PRODUCT CHANGE NOTIFICATION

PCN #: 2024-U001

E-Switch Series/ Part No affected: RDM series (all P/Ns)
See full list below

Part /Series Description:
Ultra Slim Rotary DIP Switch

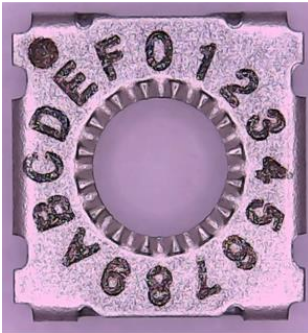
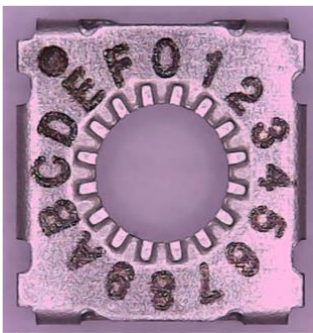
1. Improve operation force & click feeling by revising the shape of the cover detents, spring plate and actuator. Specification will change from 120 +/- 30gf to 250gf max.

Old on left. New on right.
